Site Alteration - Gravel Storage

TO: Shukria Wiar, Planner
FROM: Lauren Swett, P.E.
DATE: June 27, 2013
RE: Gravel Storage Area, Level I Site Plan Application – 410 Riverside Street

Woodard & Curran has reviewed the revised plans for the Level I Site Plan Application for the proposed gravel storage area at 410 Riverside Street in Portland, Maine. The project includes the construction of a gravel pad and associated site improvements. The project will result in an increase of 5,160 SF of new impervious area. The Applicant met with representatives from the City of Portland and Woodard & Curran on June 13, 2013 to discuss the project.

Site Plan for Gravel Pipe Storage Area and Grassed Underdrained Soil Filter BMP Detail, dated May 7, 2013, revised June 18, 2013, prepared by Colby and Associates on behalf of The Blake Group.

Grassed Underdrained
Soil Filter BMP detail

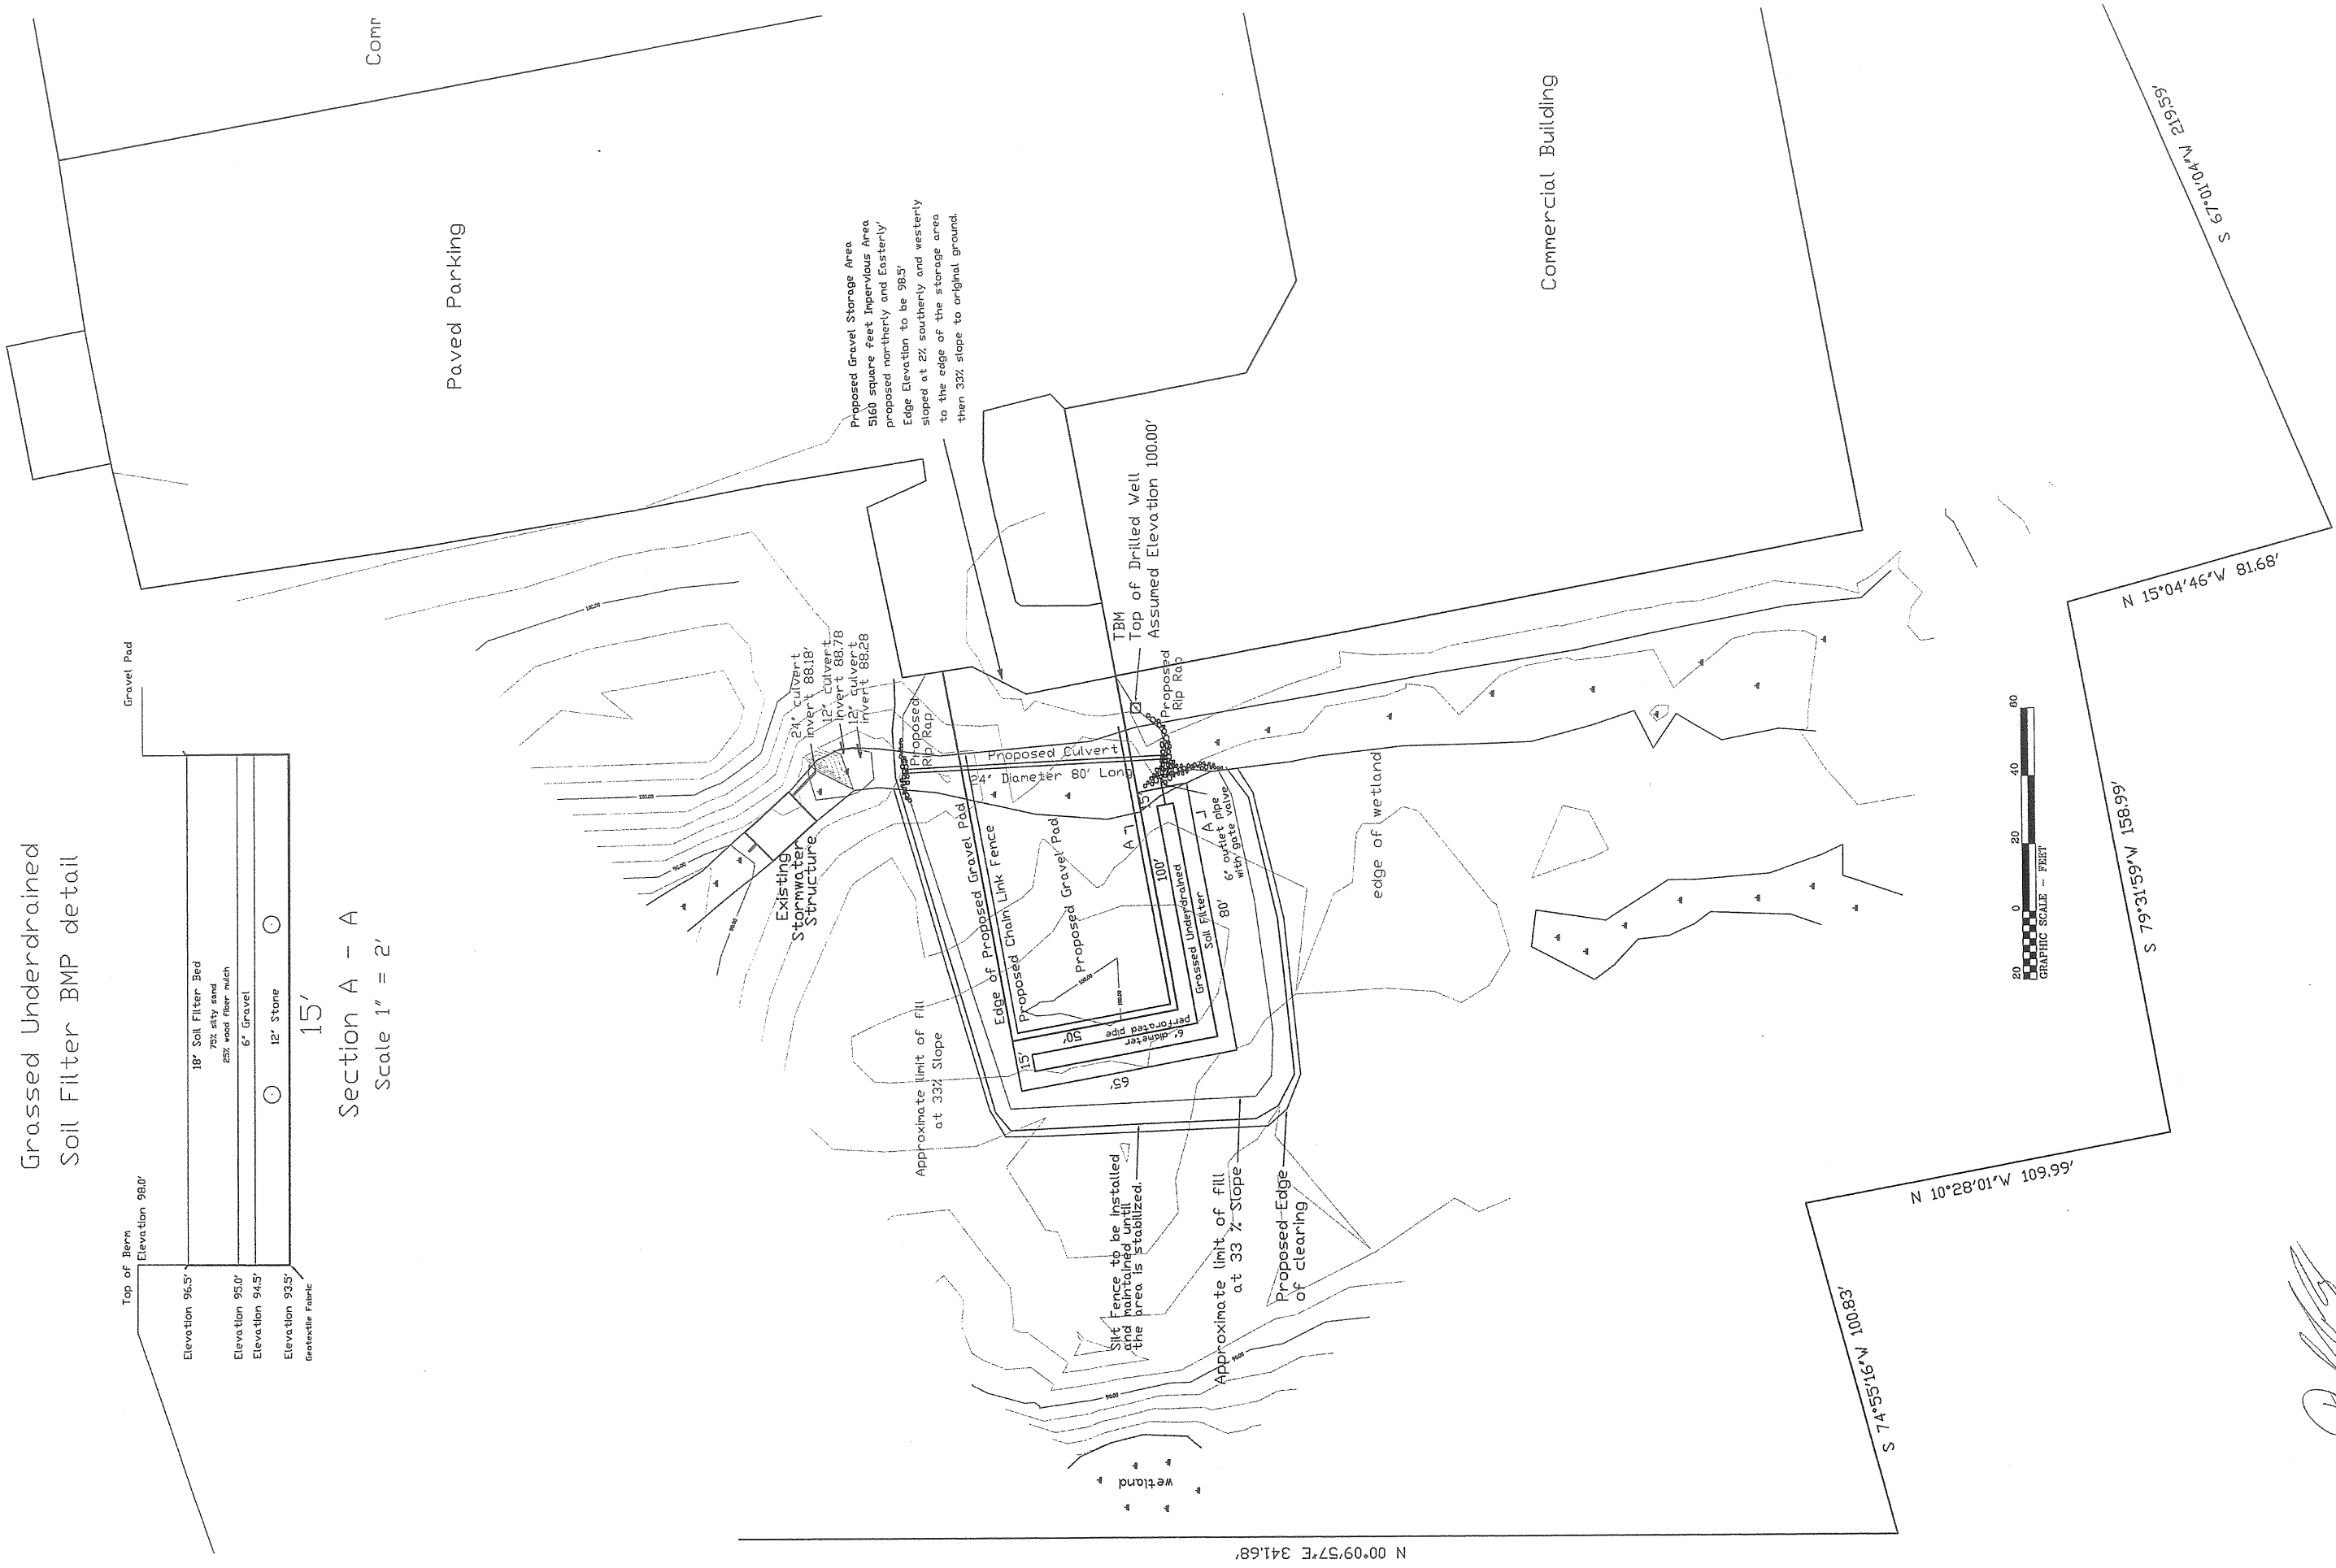
- i) The detail for the soil filter indicates that the side slopes within the filter swale will be vertical. Vertical side slopes, as shown would be difficult to construct and maintain. Typical internal side slopes are 3:1.

- ii) The geotextile separation fabric should be nonwoven.
 - iii) No invert has been provided for the 6" outlet pipe. The detail indicates that the average underdrain invert elevation within the soil filter is 93.75'. This invert is lower than the existing grade at the proposed underdrain outlet location, indicating that the outlet area may need additional grading, which may result in additional wetland impact.

- iv) It is noted that the DEP has two options for the pipe bedding beneath the soil filter bed. The Applicant has shown Option 2 which consists of a gravel transition layer over a stone layer. Option 1 may be easier to construct, as it consists of only one layer of coarse gravel equal to Maine DOT 703.22, backfill for Underdrain Type B. For the proposed 6" underdrain pipe, this layer would be 14", including 4" below and 4" above the pipe. Note that this option would raise the underdrain pipe by 6", helping to address comment b) iii) above.

- vi) The Applicant has proposed a gate valve at the 6" outlet pipe. A detail indicating the size of the gate valve should be provided.
- c) **Flooding Standard:** The project will result in an increase in impervious area of approximately 5,160 square feet. This is a relatively small area that will not result in a significant increase in flow. The Applicant is proposing to direct all stormwater from the new impervious area to an underdrained soil filter which will provide some detention, meeting the intent of the Flooding Standard.

Site Plan for Gravel Pipe Storage Area
Prepared for
The Blake Group
Property Location
410 Riverside Street Portland, Maine
Scale 1"= 50' Date: May 7, 2013
Revised June 18, 2013

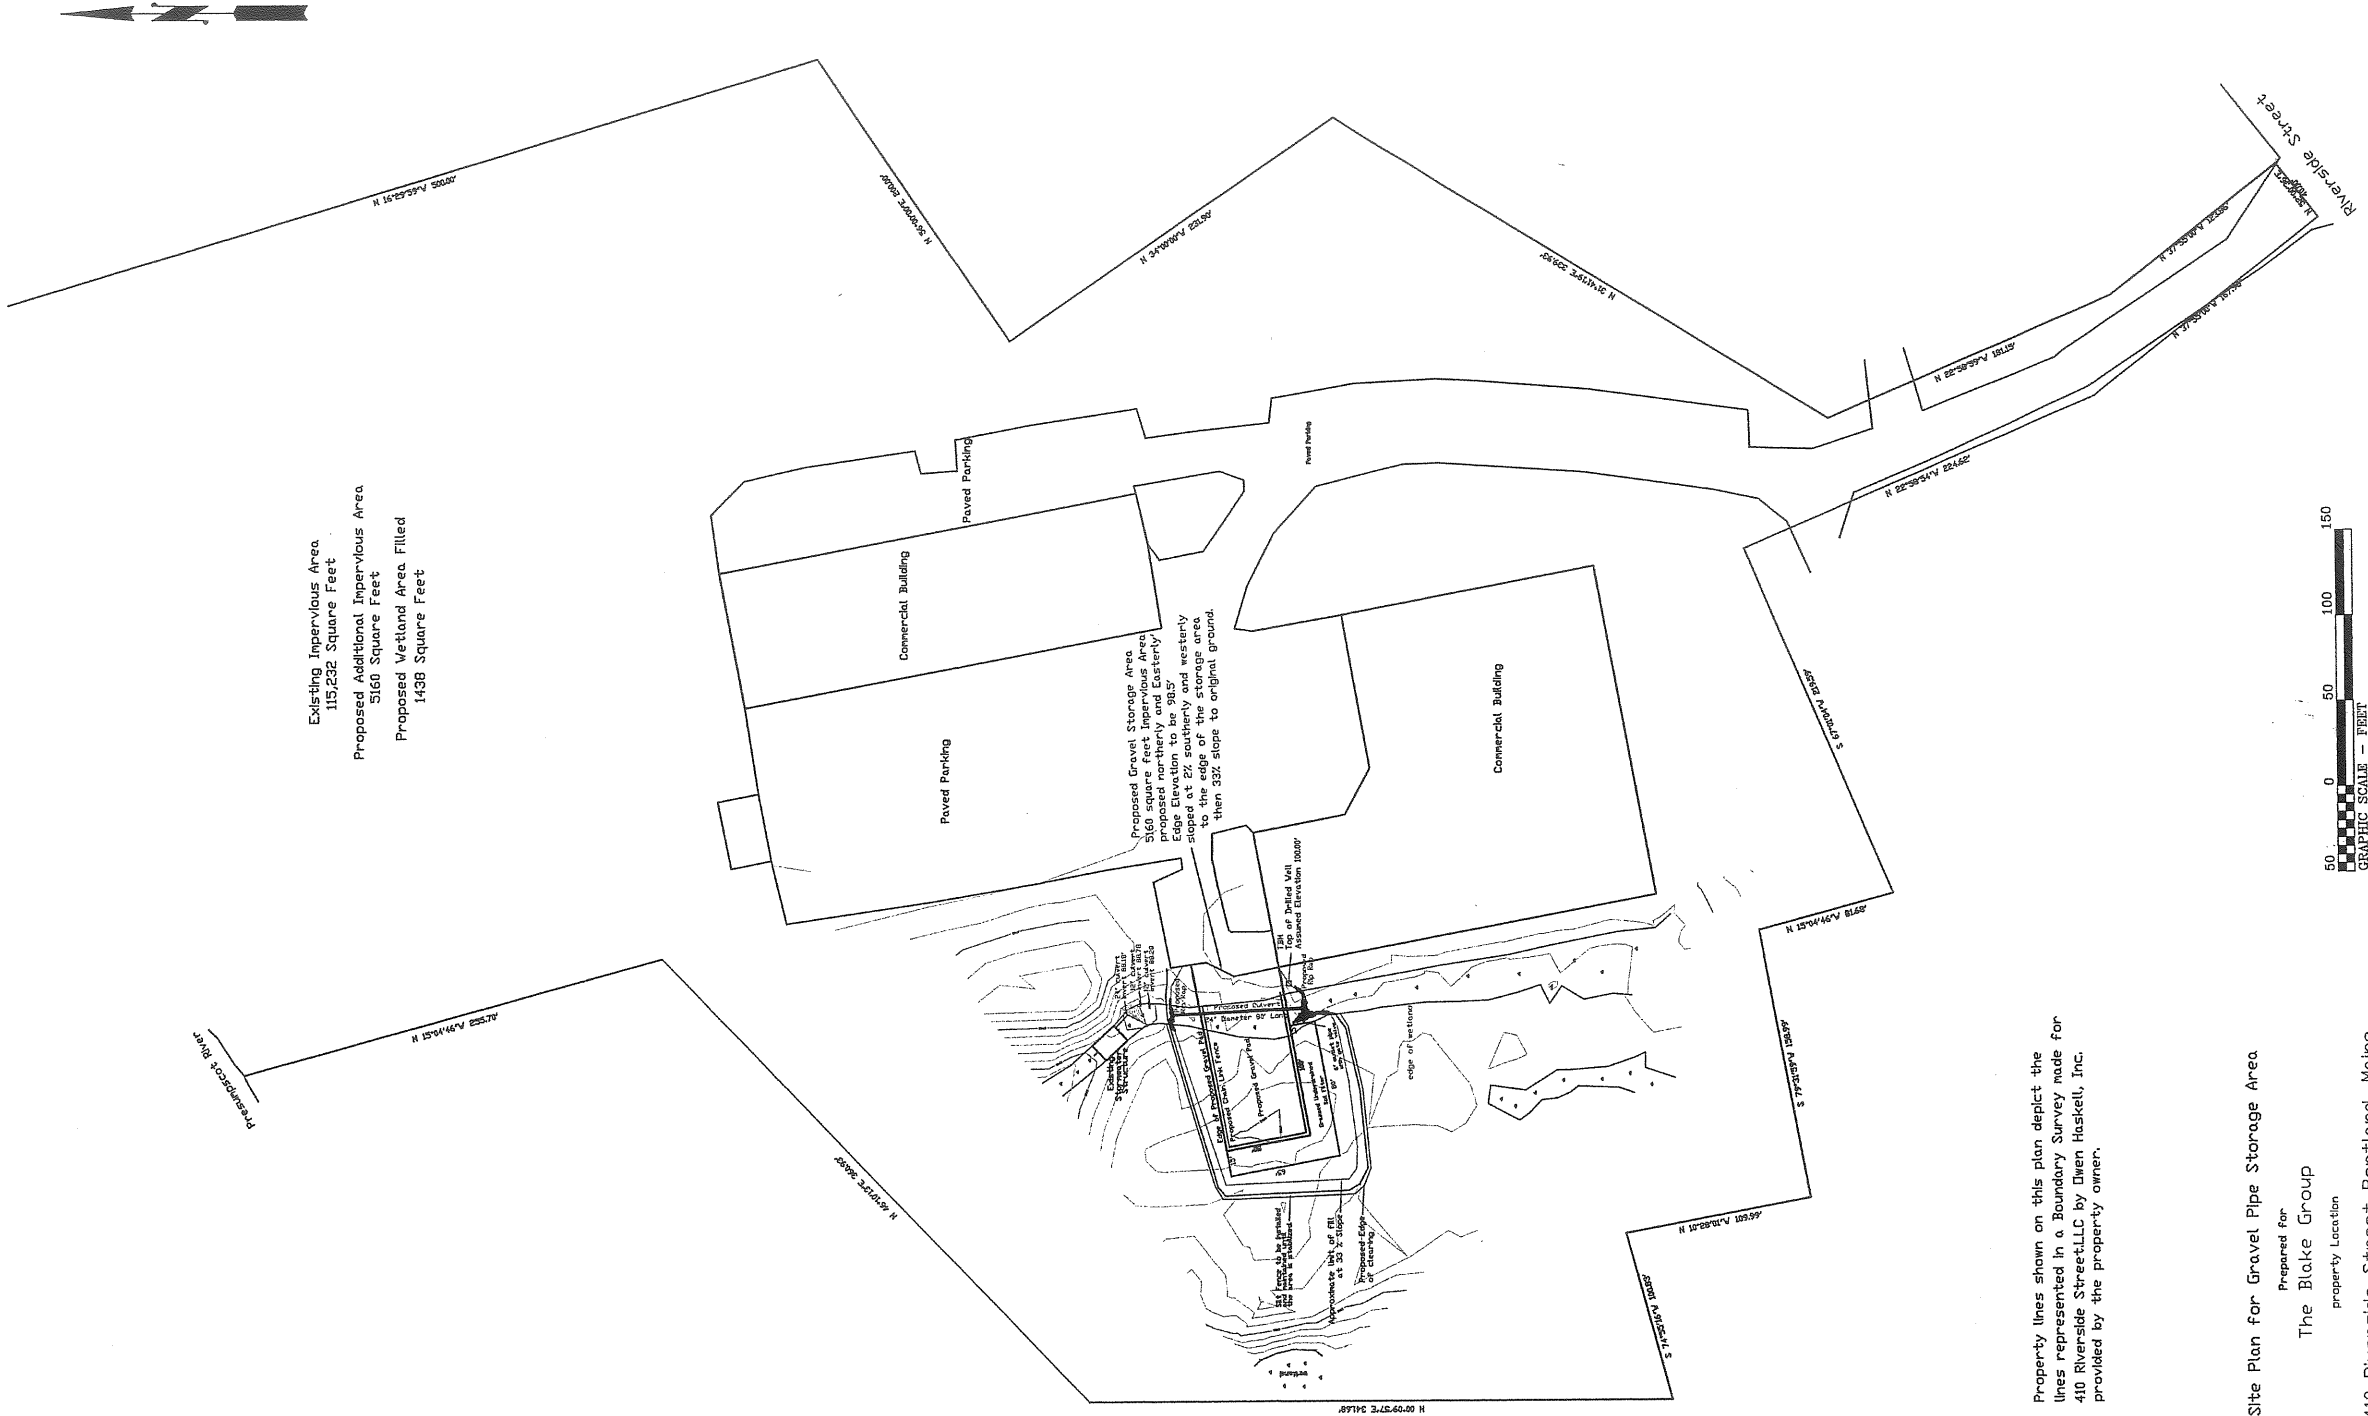
- a) **Basic Standards:** The plan includes notation regarding silt fence to address erosion and sediment control requirements in general accordance with MaineDEP Chapter 500. The Applicant should provide a detail for the proposed silt fence. The Applicant should also provide information regarding proposed permanent stabilization outside of the gravel pad area.

- v) It is our understanding that the proposed gravel pad will have a cross slope of 2% across the site, starting at an elevation of 98.5' at the north east side of the site. This would indicate that 100 feet away, at the southwest corner of the site, the elevation will be 96.5'. This elevation is the same as the elevation proposed for the soil filter bed, and lower than the exterior berm elevation of 98'. With this proposed grading, the stormwater would flood back over the gravel

pad. The grading should be modified such that a swale is provided at the soil filter. This could be achieved by lowering the soil filter and/or by changing the cross slope and elevation of the proposed gravel pad. To prevent backup of stormwater into the gravel pad, the edge of the gravel pad should be higher than the elevation of the outer berm.

- 3) The Applicant should provide invert elevations for the proposed 24" diameter culvert, showing that adequate cover can be achieved over the pipe.
